SUBJECT: Revised RAIs and Revision 2 of Supplement to the Decommissioning Plan for the TDCC Bay City, MI, Site

NRC Comment #3

**RESPONSE TO NRC REQUEST FOR ADDITIONAL INFORMATION ON REVISION 1
OF THE SUPPLEMENT DATED AUGUST 30, 2004**

The construction designs for wells I5-5 and I6-8 are provided below. The construction designs for all other wells were

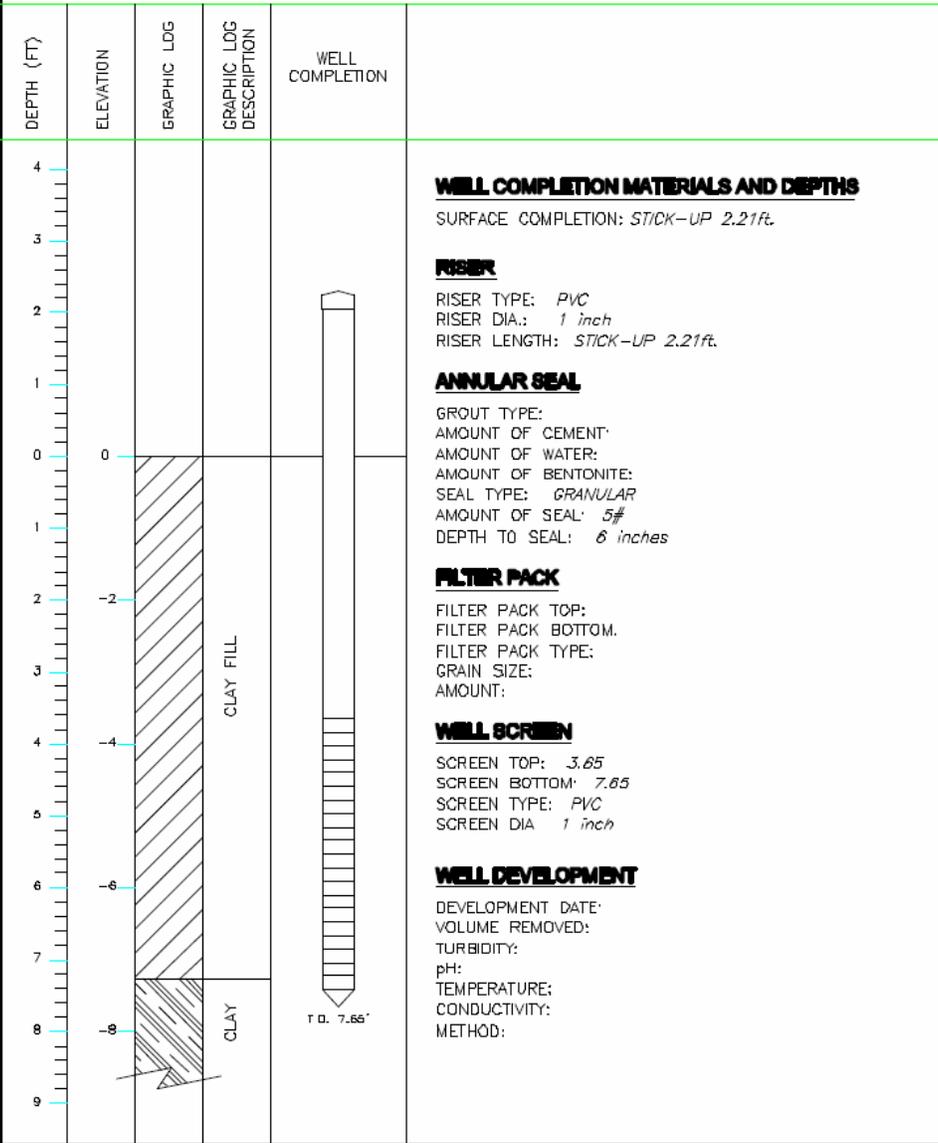
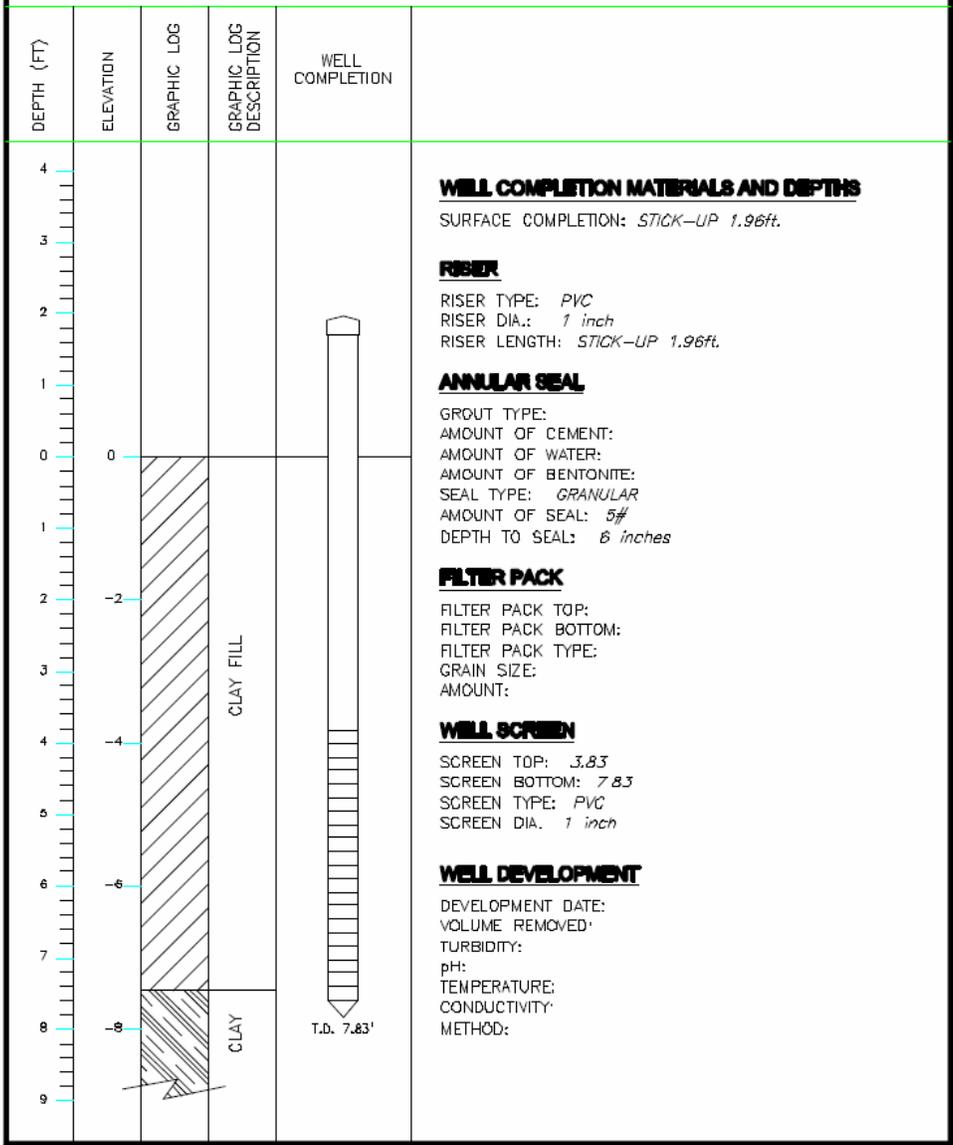
Section 3.3, Unrestricted Use Criteria for Groundwater in Saturated Zone - In the first paragraph of this section you state, "compliance will be demonstrated using the spatial average from the wells designed in the TDCC groundwater monitoring plan (to be submitted at a later date)." Submit the monitoring plan with your responses to the RAIs

previously submitted to NRC. The construction of wells I5-5 and I6-8 was different from the remaining wells. Therefore, wells I5-5 and I6-8 will be removed before remediation and reconstructed in the same location after remediation in the area is completed. The new I5-5 and I6-8 wells will have a 5 ft screen depth and a 2 in screen diameter to match the design of the remaining wells. The depth of the new wells will be approximately the same as the depth shown in the attached diagrams.

FIGURE 8 - LOCATION AND RESULTS OF 750 BOREHOLE SAMPLES COLLECTED FROM THE SATURATED ZONE

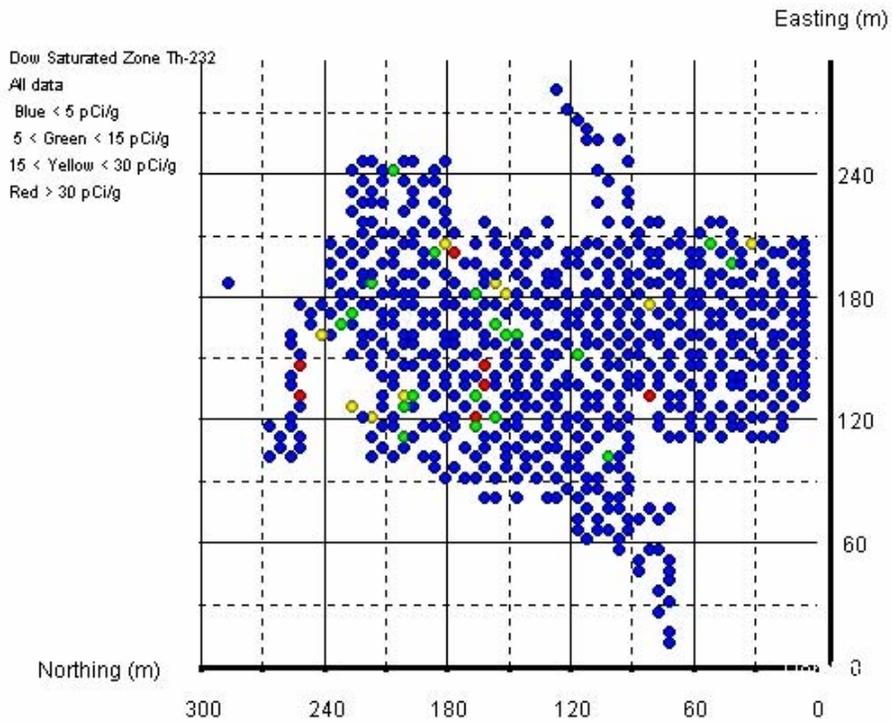
Incomplete Sampling - Revision 1 of the Supplement indicates that the ~750 boreholes will provide sufficient characterization and final status survey (FSS) sampling for the saturated zone. However, we note that some of the subgrids (100 m² areas) have not yet been sampled. For example, samples apparently have not been taken in subgrids E8-7, E8-8, E8-9, E9-7, E9-8, and E9-9. This situation also may be applicable to the unsaturated zone characterization. Describe how the characterization and FSS surveys will be completed for these and all subgrids of the 9.1 acre area (for both the unsaturated and saturated zones).

No data was reported for the subgrids listed in Comment #8 because the geoprobe sampling equipment could not penetrate the subsurface material in these subgrids. Field personnel that were present when the sampling was being performed reported that refusal was met due to the presence of large quantities of a plastic sheeting material. Attempts were made to sample at various locations within a given quadrant if refusal was encountered during the initial effort at the center of the quadrant. These areas are not believed to contain significant quantities of contaminated slag since it is evident by inspection that waste material from a production process other than Mg-Th alloy was used as fill in these areas.
